Rezoning Transportation Analysis

Petition Number: 2021-169

Date	Description
11-19-2021	First Review (KP)
12-20-2021	Second Review (KP)

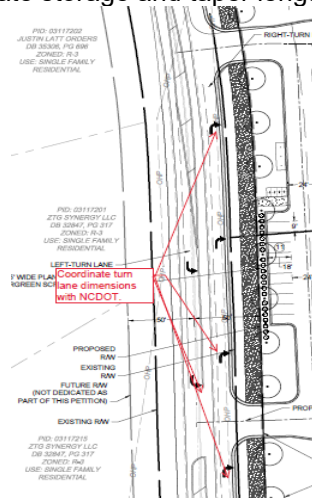
- a. ~~Mount Holly-Huntersville Road: The location of back-of-curb and gutter shall be placed 30-feet from the existing road centerline.~~

~~Label and dimension the curb and gutter from the centerline to the back-of-curb.~~

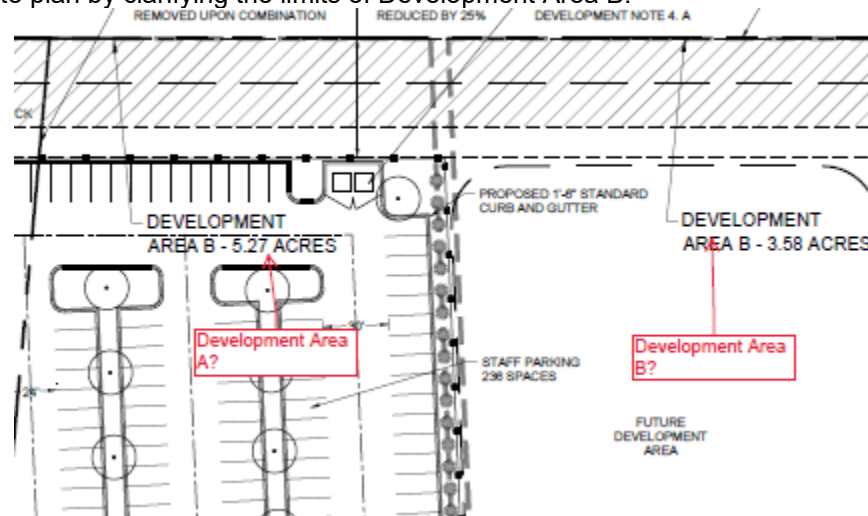
4. ~~Revise the conditional notes by committing to construct the left turn lane and right turn lane into the site as generally depicted on the site plan. Additionally, commit to coordinate with NCDOT, during permitting, to determine the appropriate storage and taper lengths for each turn lane.~~
